**RE: WINE COUNTRY DRIVE (B82): NOTIFICATION OF MOD8 TO STAGE 1 PROJECT APPROVAL FOR HUNTLEE NEW TOWN, WINE COUNTRY DRIVE, BRANXTON (MP 10\_0137 MOD 8)**

Attachment A – Technical Response to NSW RMS Correspondence to NSW Department of Planning & Environment Dated - 21 June 2017

## Attachment B – Distribution and Flow Diagrams (UPDATED 4 August 2017)

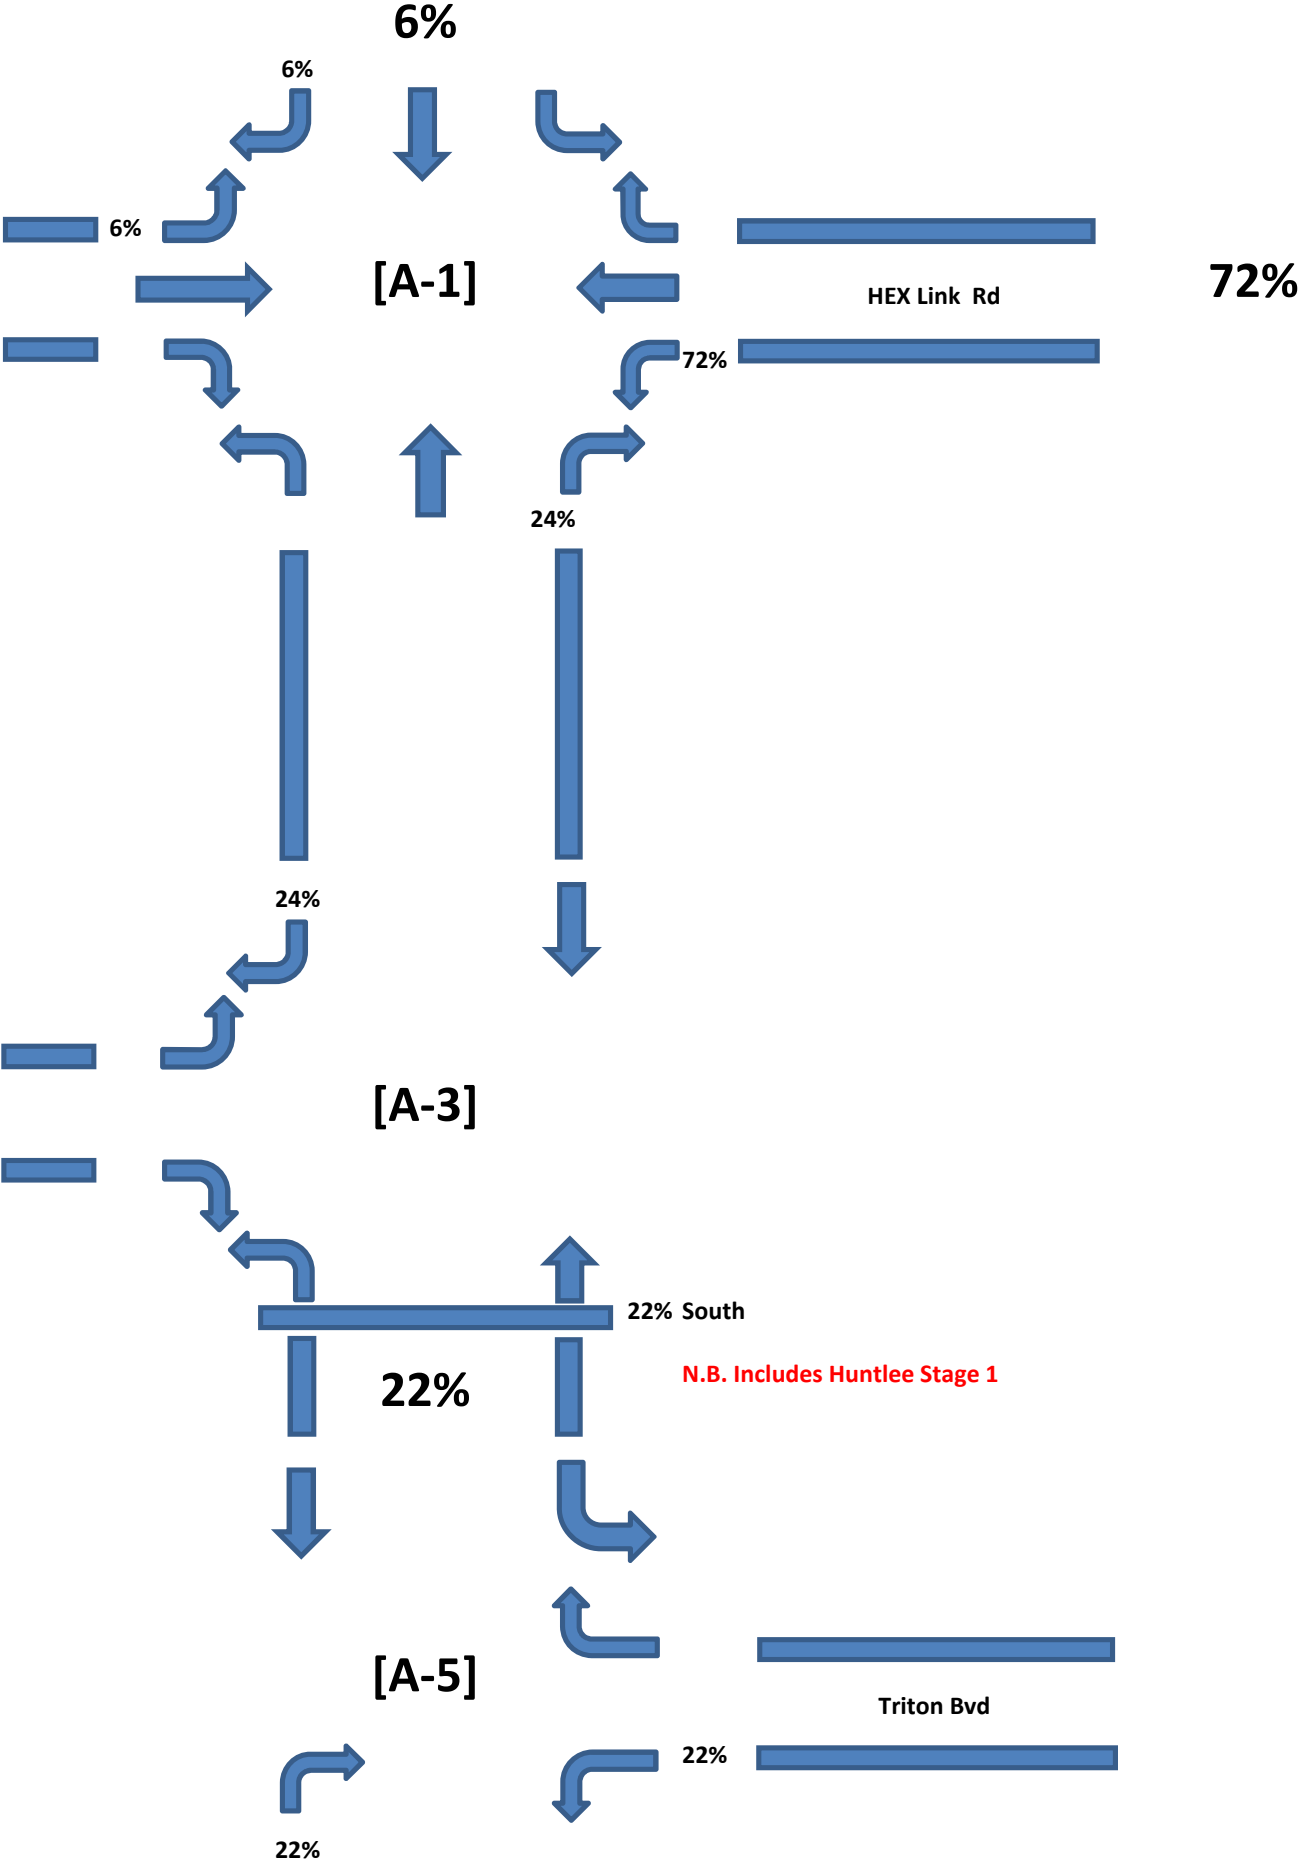
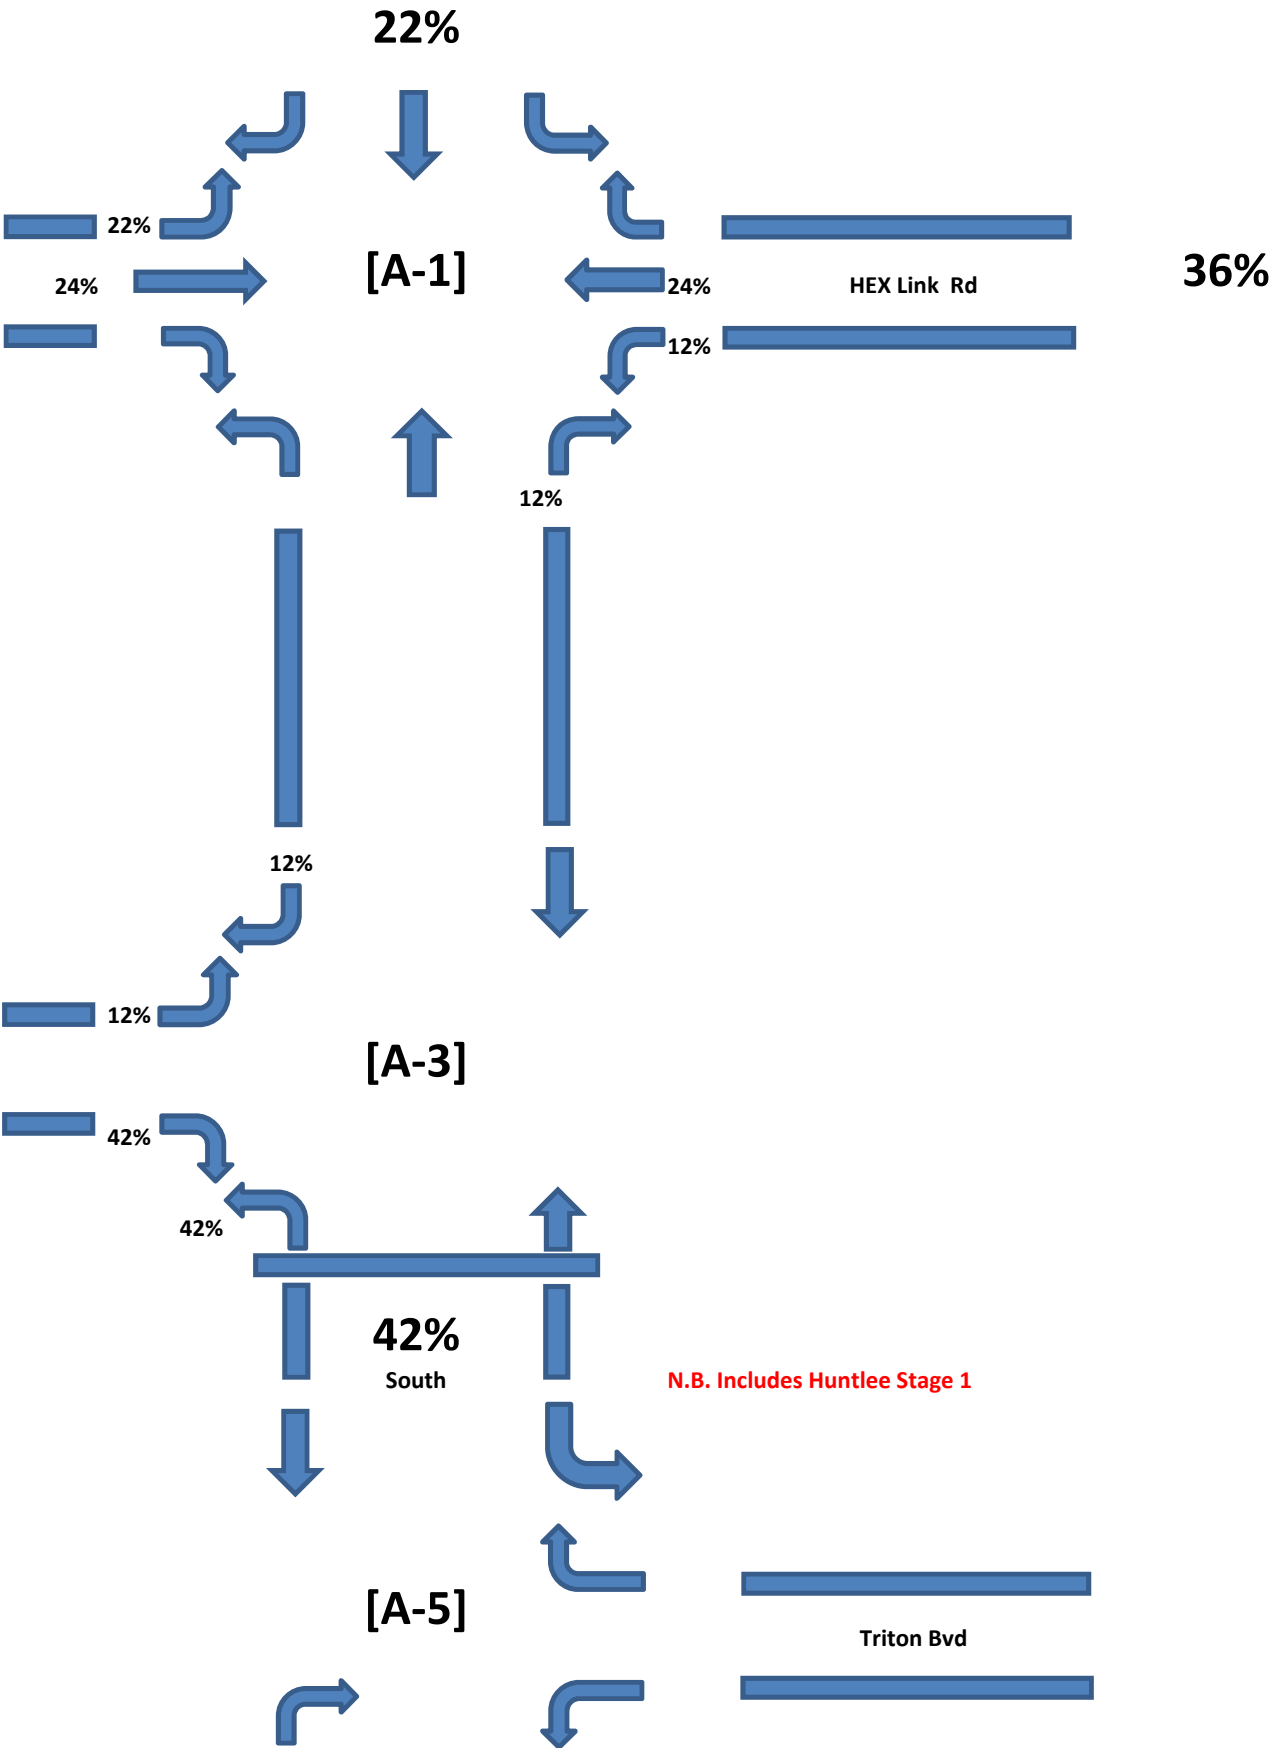
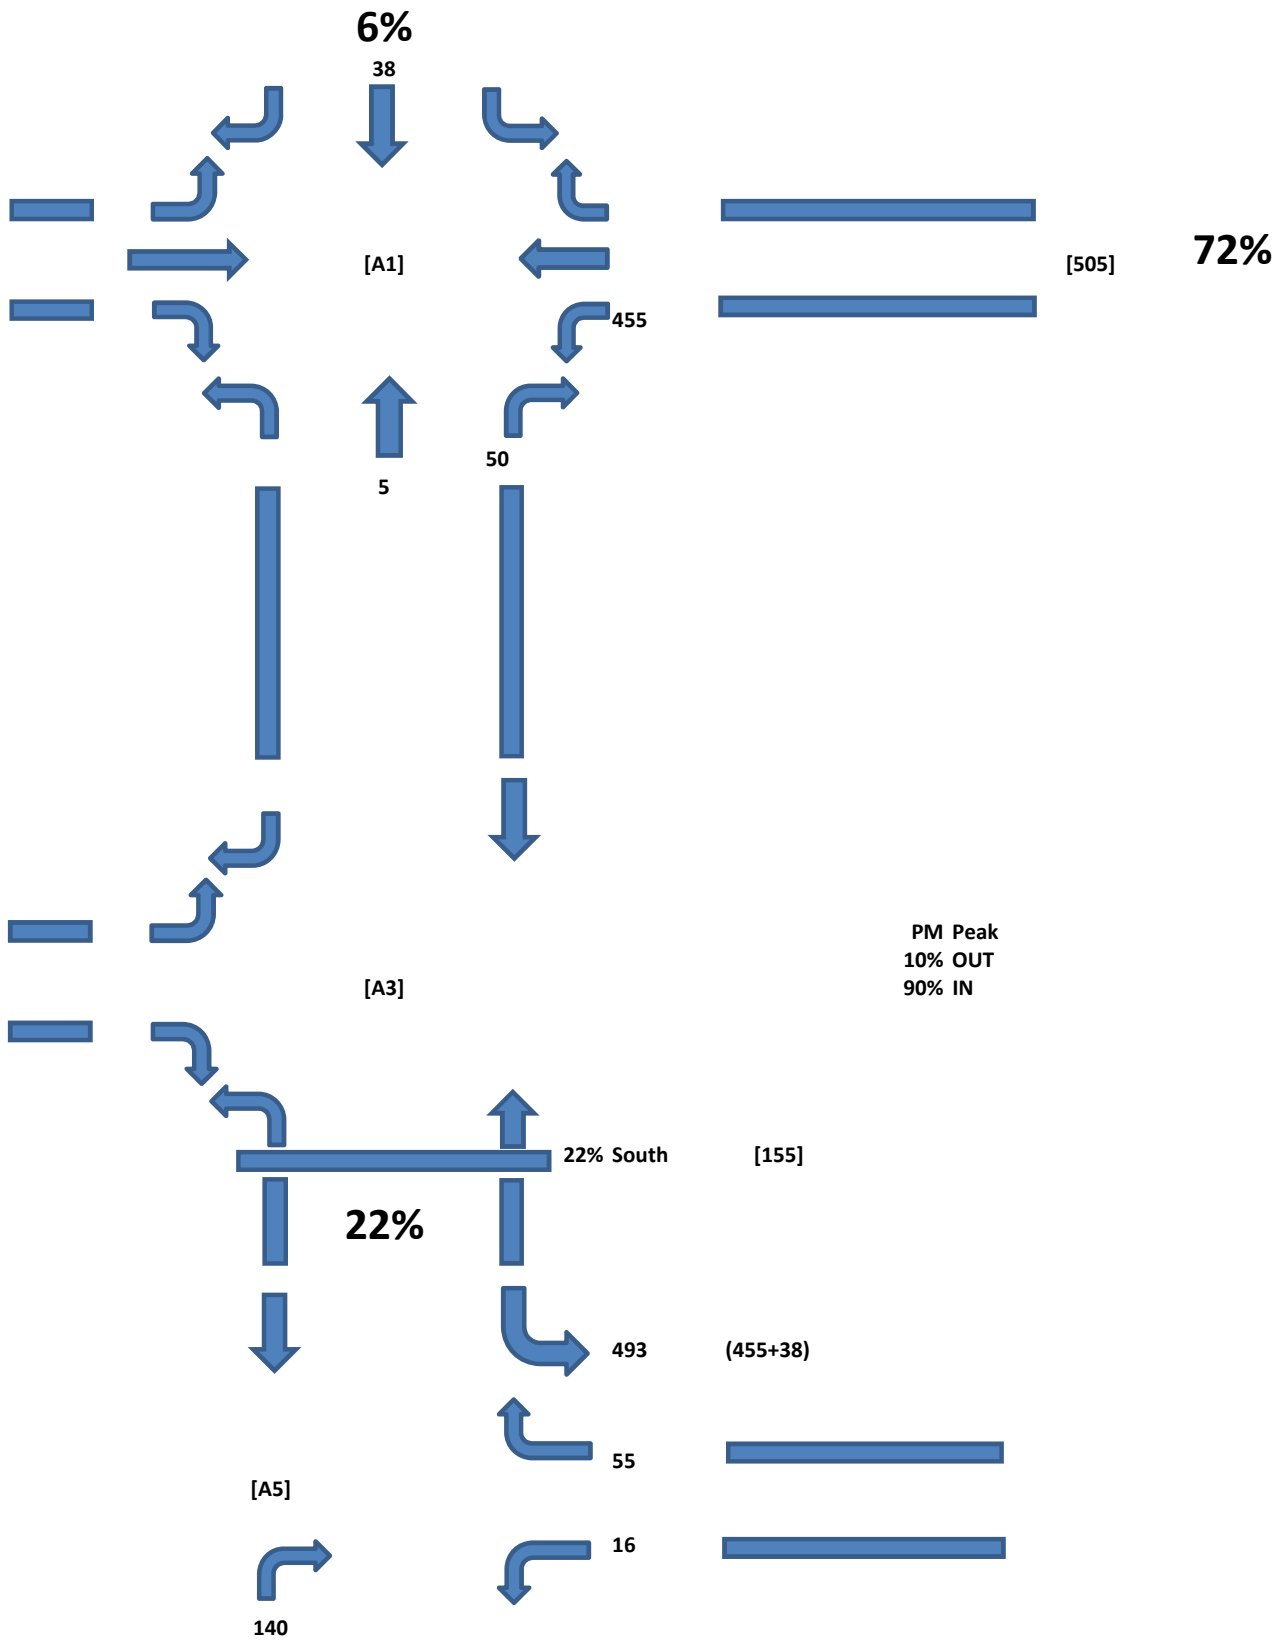
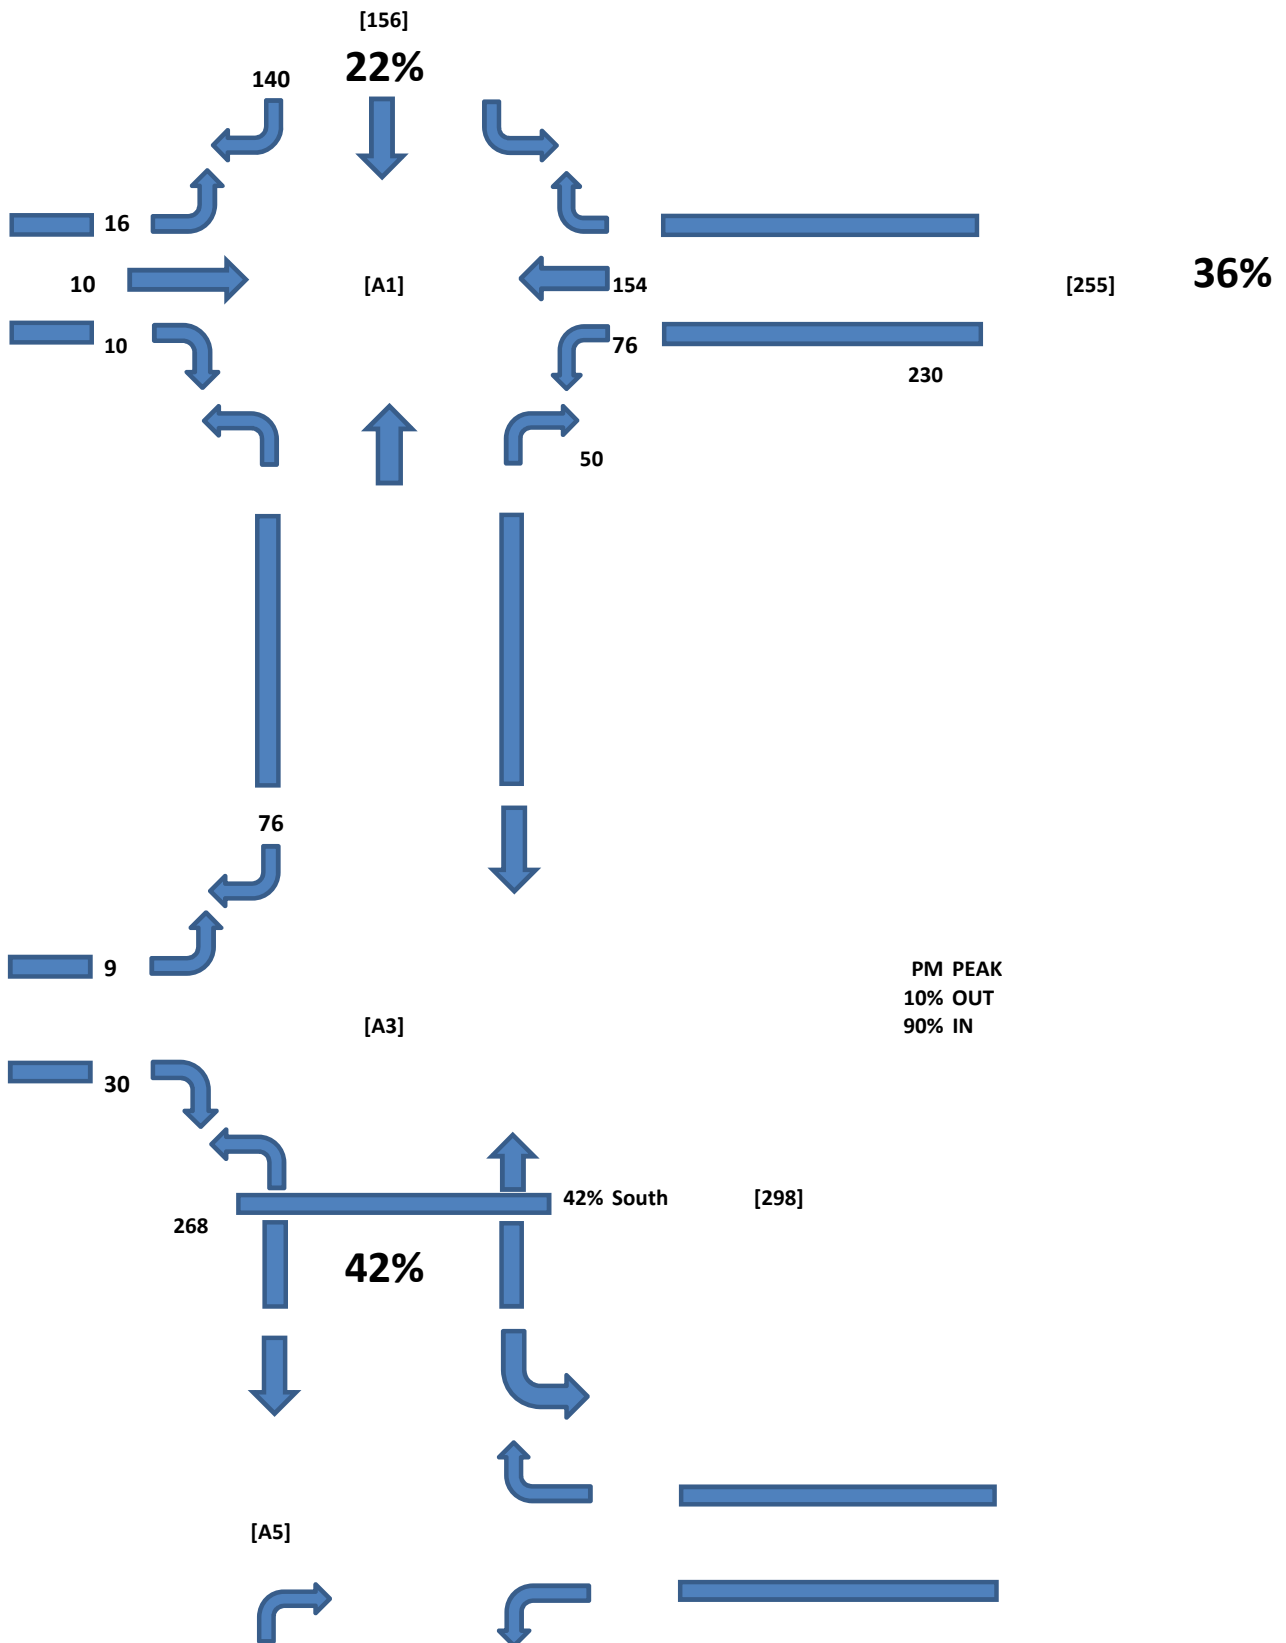
1	<p><i>Provide the distribution of trips associated with the developments (plus existing traffic utilising the network), shown diagrammatically to determine what traffic will be utilising the roundabout at Wine Country Drive and Hunter Express Link Road, and what traffic will be distributed through the network to other intersections (if they are operational prior to reaching the 900 lot threshold requested).</i></p>	- BTF	<p>See Attached diagrams. The higher flows on HEX Link Rd appear to represent a test of the PM capacity threshold beyond the 900 lot and Town Centre trip generation.</p> <p>Given the time elapsed, a full 1<sup>st</sup> principles review was conducted of the distribution and assignments nominated in the BTF Design Note. This has assumed the nominated distributions, noting that the PM Town Centre assignment should be 90% IN, 10% OUT for the PM peak analysis. The flows derived from this distribution and assignment are LOWER than either of the previously nominated SIDRA files, particularly on the HEX link Rd approach. An additional run has been completed, and confirms the roundabout will operate at better than LoS D nominated. The SIDRA Files and there resultant Worst Movement LoS for the HEX Link Road approach are:</p> <p><u><b>A-1 PM 900 - 4 leg – 270417 (900 Lots +~400 trips Hex Link PM)</b></u>  <u><b>A-1 PM 900 + TC Mod D&amp;A- 4 leg – 280417 (900 Lots +~200 trips)</b></u>  <u><b>A-1 PM 900 + TC Mod D&amp;A- 4 leg - 280417 - 50m Rbt</b></u>  <u><b>A-1 PM 900 + TC Mod 8 1st Principles - 4 leg – 270717 (900 Lots)</b></u>  <u><b>A-1 PM 900 + TC Mod 8 1st Principles - 4 leg 50m Rbt - 270717</b></u></p>	<p>26/07/17</p> <p>Los F Los D Los C Los B Los B</p>

2. Diagrammatic representation of forecast traffic flows – the sequence of diagrams (hand drawn) that represent the distributions and assignments at the intersections are attached. The basis of determining the town centre distribution of traffic flows was documented in the April 2017 Design Note.

Mod 8 (PM) BASE (RMS20) + With Development Flows

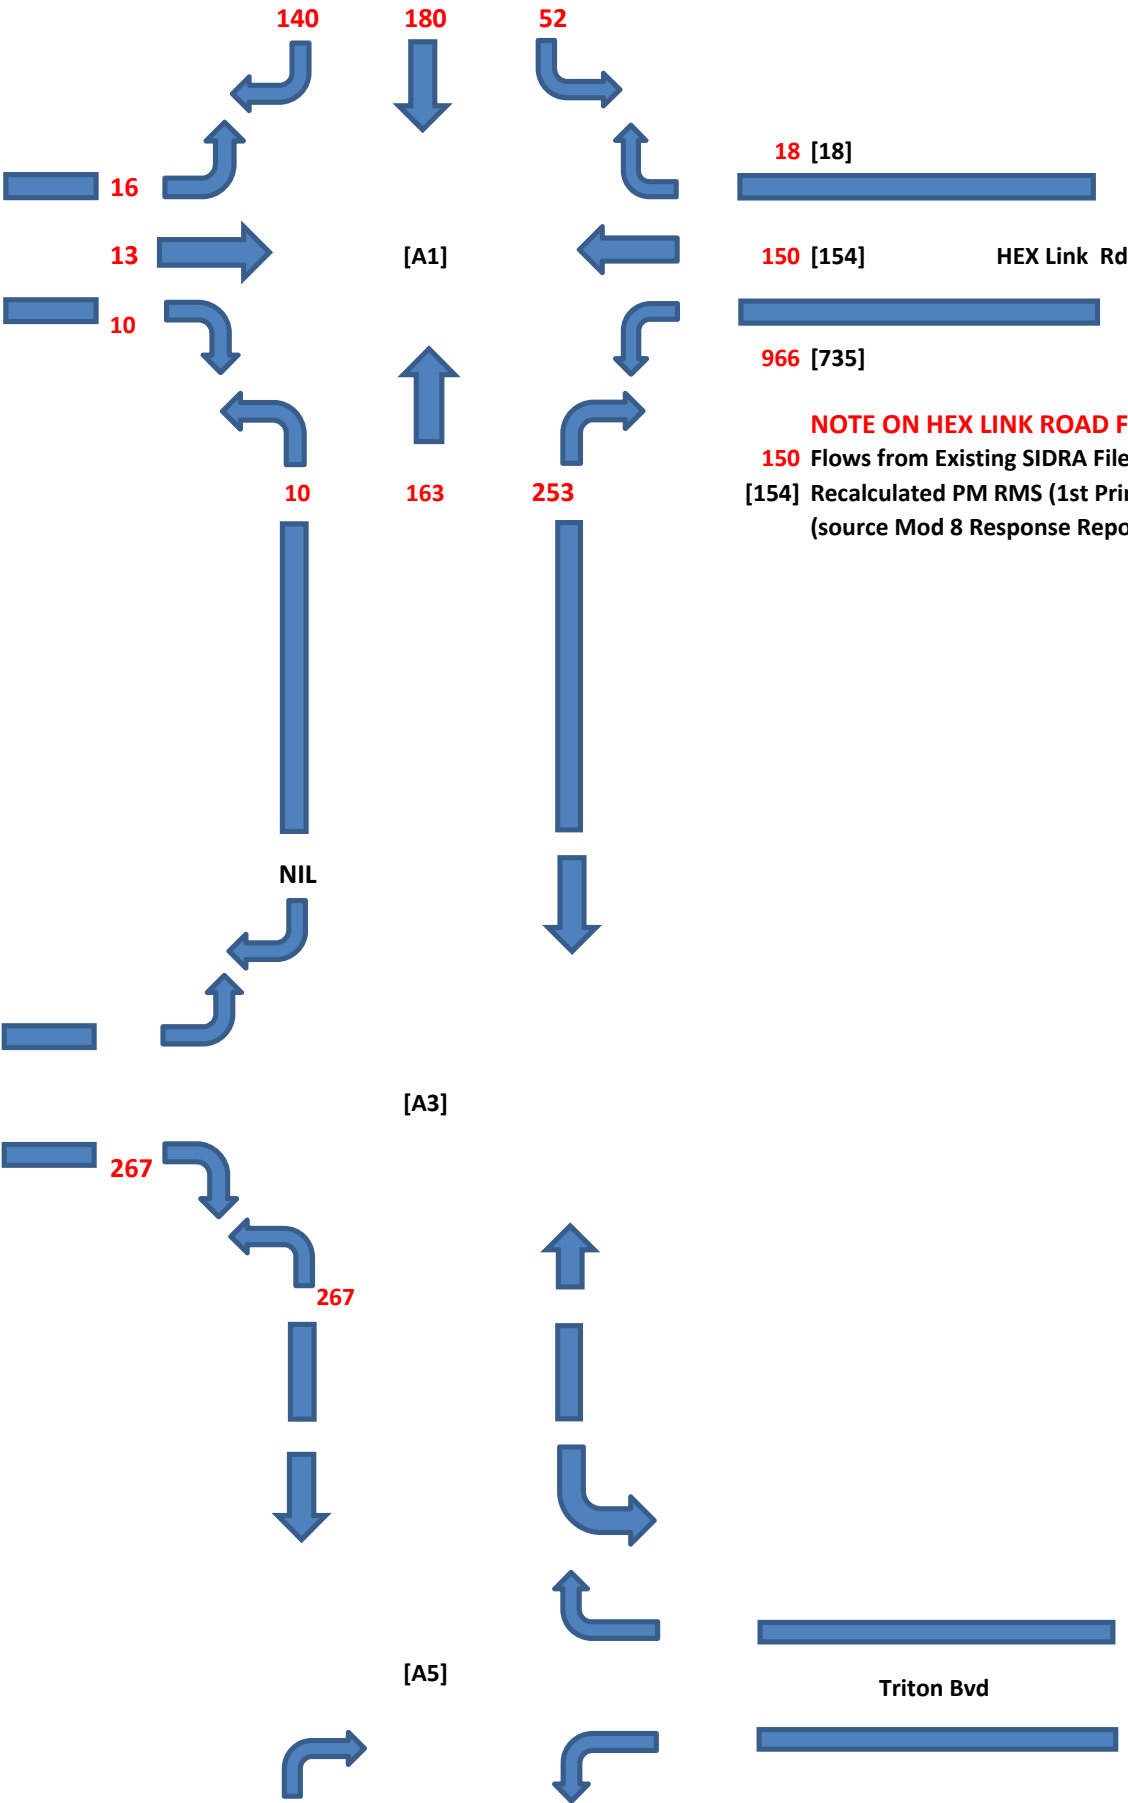
**NOTE ON HEX LINK ROAD FLOWS**  
150 Flows from Existing SIDRA File PM (Apr17)  
[154] Recalculated PM RMS (1st Principles)  
(source Mod 8 Response Report Jul17)
